**Draft Final Revised Butte Reduction Works (BRW) Smelter Area  
Mine Waste Remediation and Contaminated Groundwater  
Hydraulic Control Site Pre-Design Investigation (PDI) Evaluation  
Report**

**RE: Draft Final Revised Butte Reduction Works (BRW) Smelter Area Mine Waste Remediation and Contaminated Groundwater Hydraulic Control Site Pre-Design Investigation (PDI) Evaluation Report**

**RESPONSE TO AGENCY COMMENTS  
FOR THE BUTTE PRIORITY SOILS OPERABLE UNIT (BPSOU)  
BUTTE REDUCTION WORKS (BRW)  
SMELTER AREA MINE WASTE REMEDIATION AND  
CONTAMINATED GROUNDWATER HYDRAULIC CONTROL SITE  
PRE-DESIGN INVESTIGATION (PDI) EVALUATION REPORT  
DATED MAY 14, 2021**

**BRW SMELTER AREA  
 CONCEPTUAL REMEDIAL  
 ACTION PLAN**

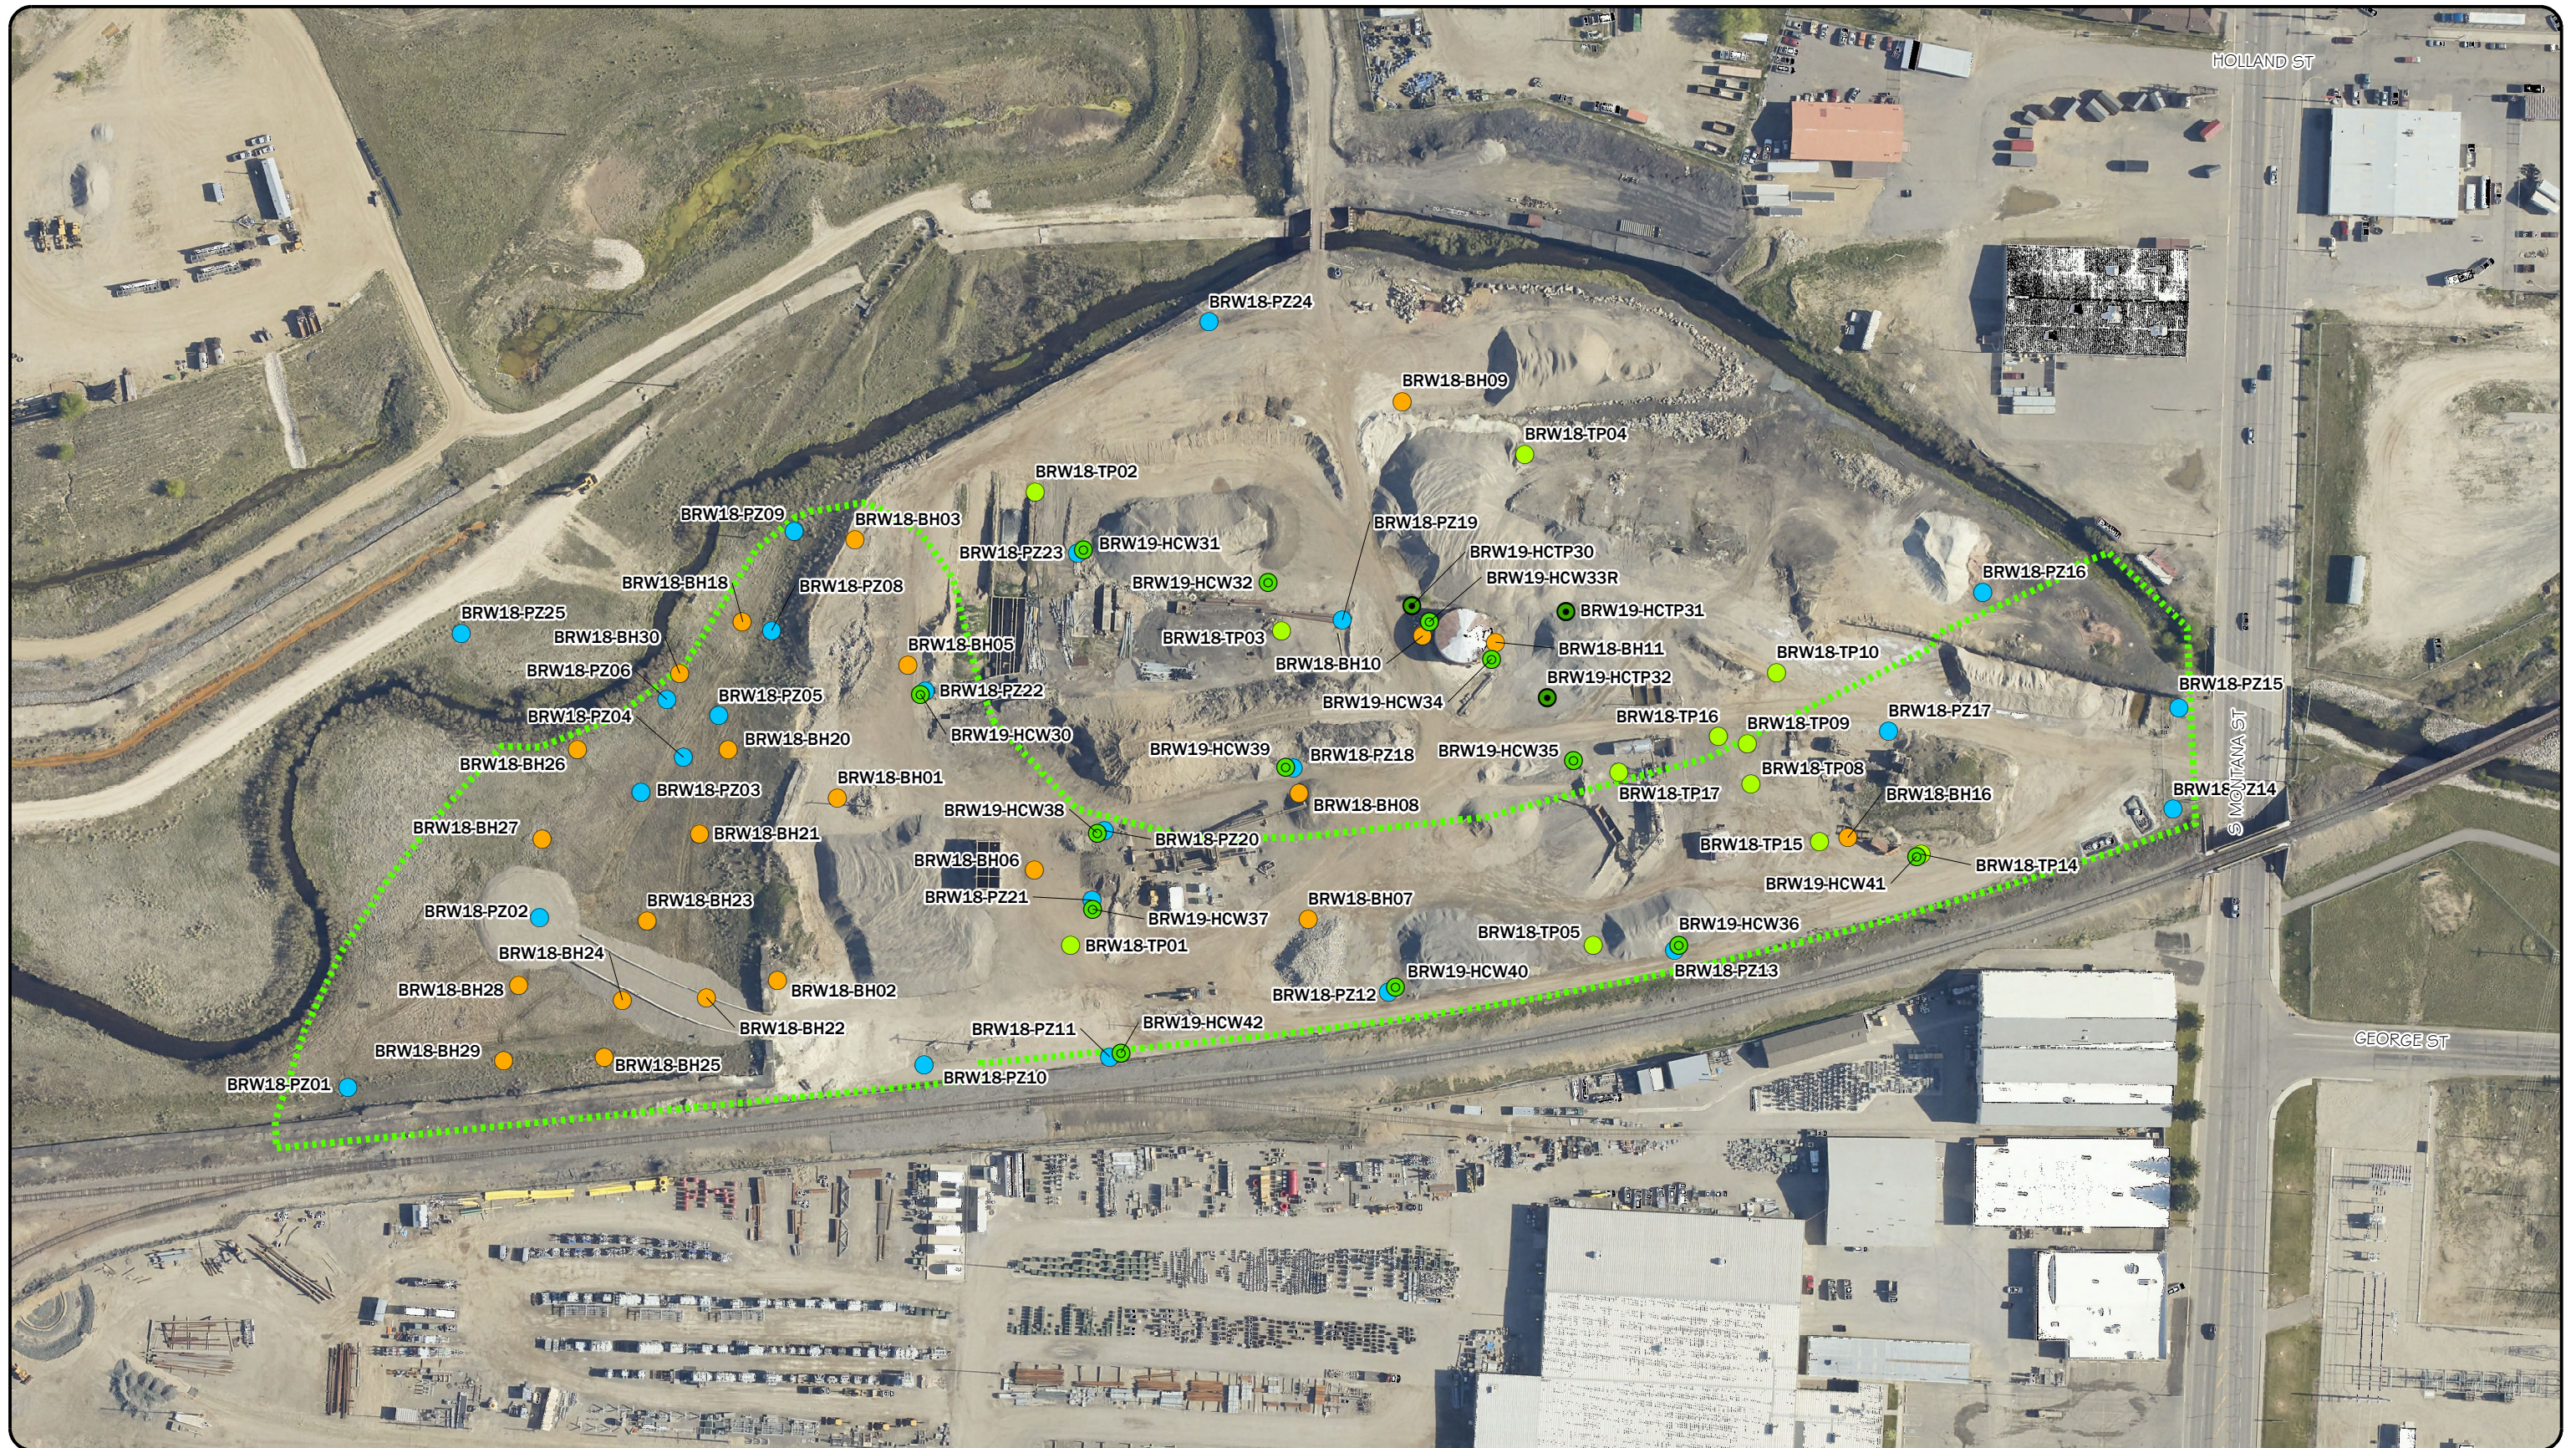
**EPA Specific Comment 5:** *Section 2.2: The fourth bullet uses Figure BRW-1 of the CD for the site boundary. This same figure has a conceptual removal corridor. Why wasn't this removal corridor used in the model? The proposed removal corridor shown on Figure 3 has not been approved at this time.*
